### REMARKS

Claims 1-18 are pending in this application. Claims 1-6 were variously rejected under 35 U.S.C. § 112, second paragraph. Claims 1-3, 7-9 and 13-15 were variously rejected under 35 U.S.C. § 103(a). Claims 10-12 and 16-18 were objected to. Drawing Figures 1 and 4 were variously objected to under 37 C.F.R. 1.84(p)(5).

Figure 1

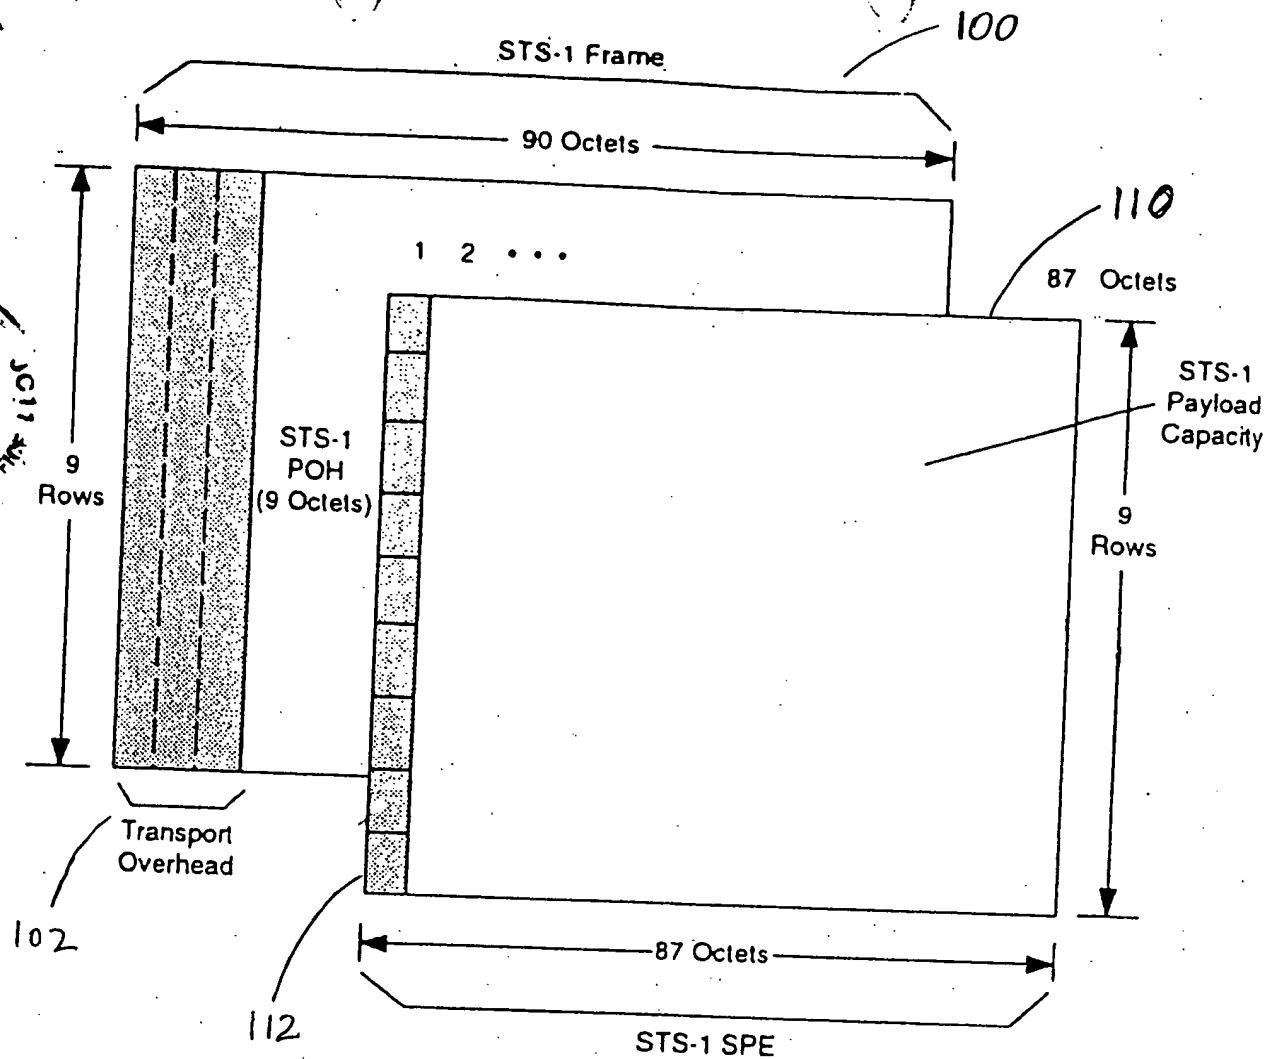
Drawing Figures 1 and 4 were objected to as failing to comply with 37 C.F.R. 1.84(p)(5) because they do not include certain reference signs mentioned in the description. Figure 1 was also objected to as failing to comply with 37 C.F.R. 1.84(p)(5) because it includes certain reference signs not mentioned in the description. Drawing Figure 1 was additionally objected to for failure to designate a legend indicating only that which is old is illustrated. Applicant respectfully traverses these objections.

Regarding Figure 1, the Examiner stated that the following reference signs were mentioned in the description and not included in Figure 1: “‘first column 210,’ ‘SPE 200,’ ‘POH data 210’ (see page 2, lines 11-13; Figure 1).” See 19 February 2004 Office Action, page 2 (hereinafter “Office Action”). The Examiner also stated that the following reference signs were

included in Figure 1 and not mentioned in the description: "Figure 1, '110,' '112.'" *See id.* Finally, the Examiner requested that Figure 1 be designated by a legend such as "--Prior Art--." *See id.*

Accordingly, Applicant has amended the specification paragraph at page 2, lines 1-16 to as follows: (1) "first column 210" (page 2, line 11) has been amended to "first column 112," (2) "SPE 200" (page 2, line 12) has been amended to "SPE 110," and (3) "POH data 210" (page 2, line 13) has been amended to "POH data 112." Reference signs "210" and "200" in the first paragraph of page 2, as originally filed, constitute typographical errors, which should have been labeled "112" and "110," respectively. Figure 1 contains no reference signs labeled "210" and "200," but does indeed include reference signs labeled "112" and "110" that match the written specification at page 2, lines 1-16, as now amended. Applicant's specification amendment of the reference signs "210" and "200" to "112" and "110," respectively, also moots the Examiner's objection that the reference signs "110" and "112" in Figure 1 are not mentioned in the description.

Figure 1 has been corrected to include the legend "--Prior Art--" per the Examiner's request.

FIG. 4

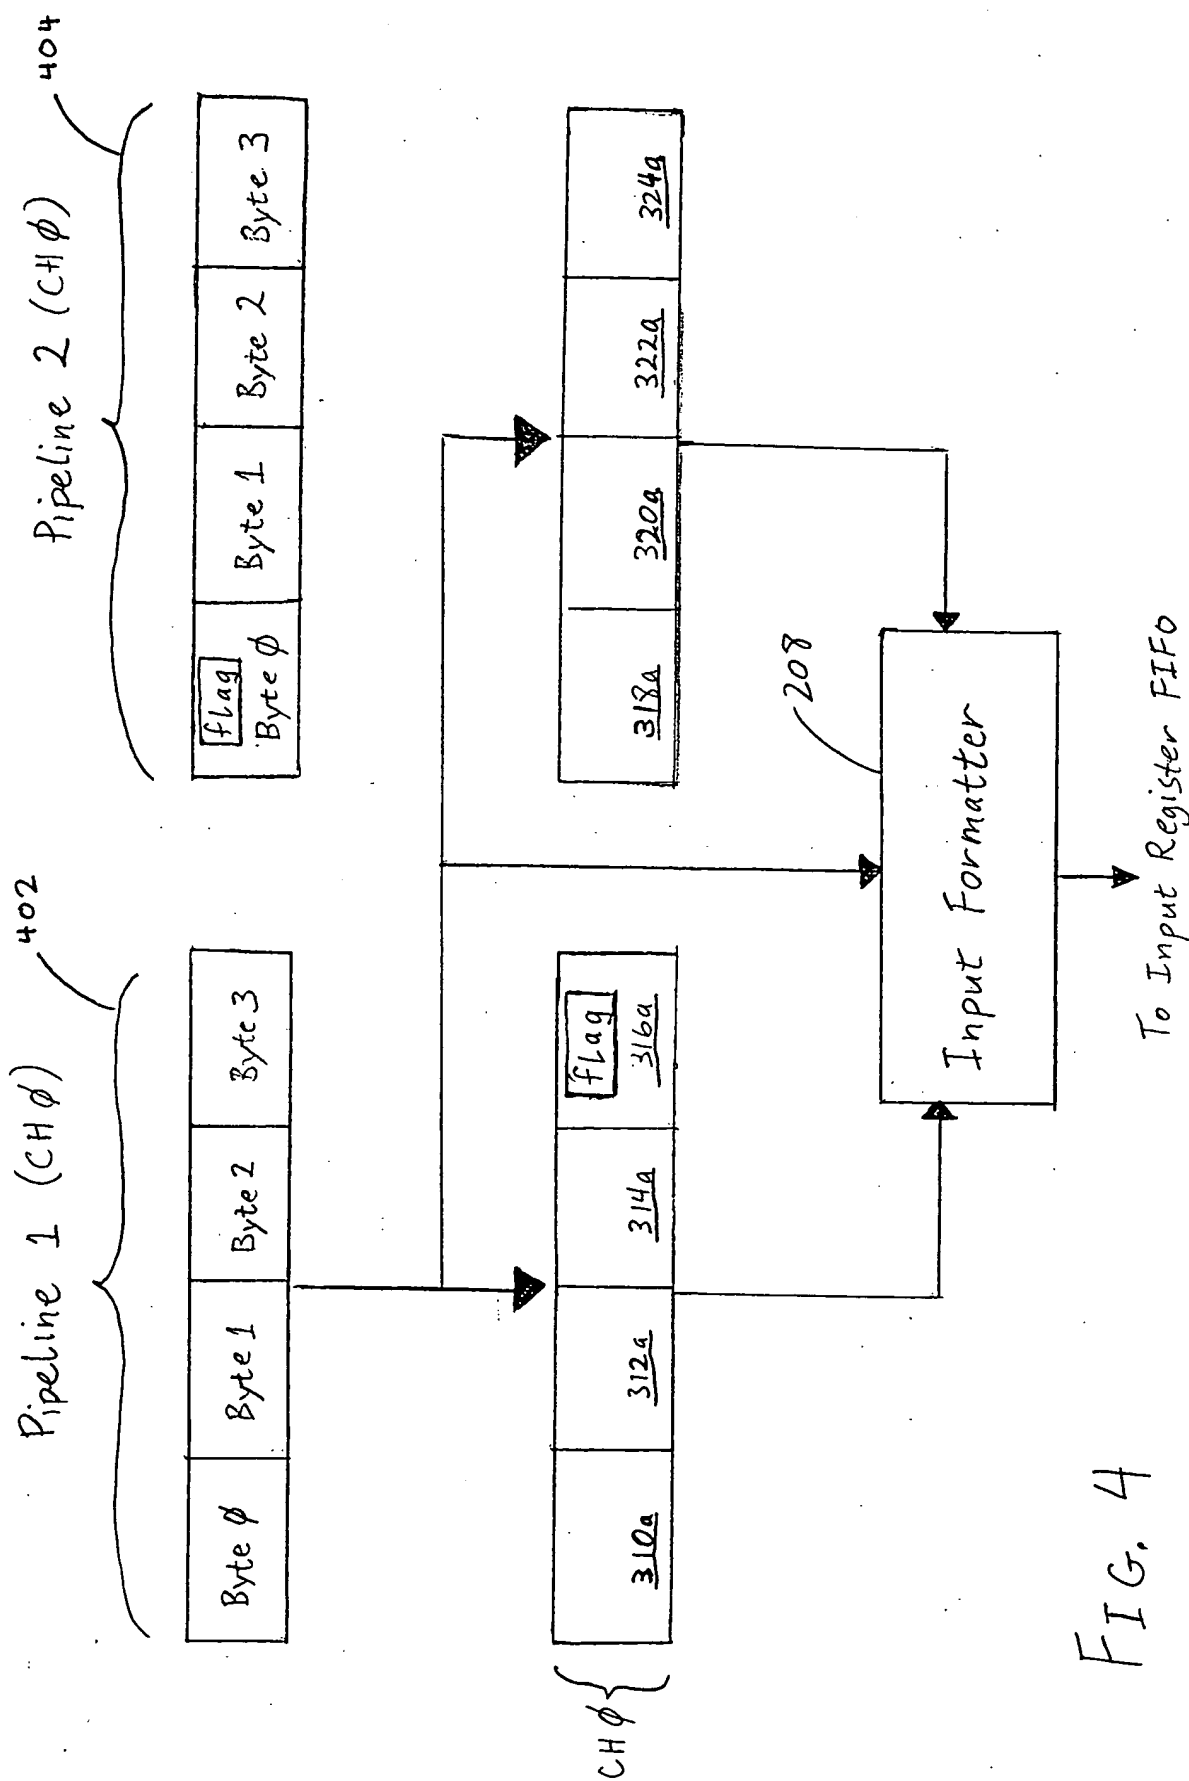
Regarding Figure 4, the Examiner stated that the following reference signs were mentioned in the description and not included in Figure 4: "'pipeline 402,' 'pipeline 404' (see page 1, lines 11, 19, 26, 28-29; Figure 4)." *See id.*

Figure 4 has been corrected to include the reference signs "402" and "404" per the Examiner's request. Corrected drawing Figure 4 includes the reference sign "402" near the text "Pipeline 1 (CH 0)" and the reference sign "404" near the text "Pipeline 2 (CH0)." These corrections are consistent with the written description language at page 11, lines 11, 19, 26, 28-29, referring to Figure 4.
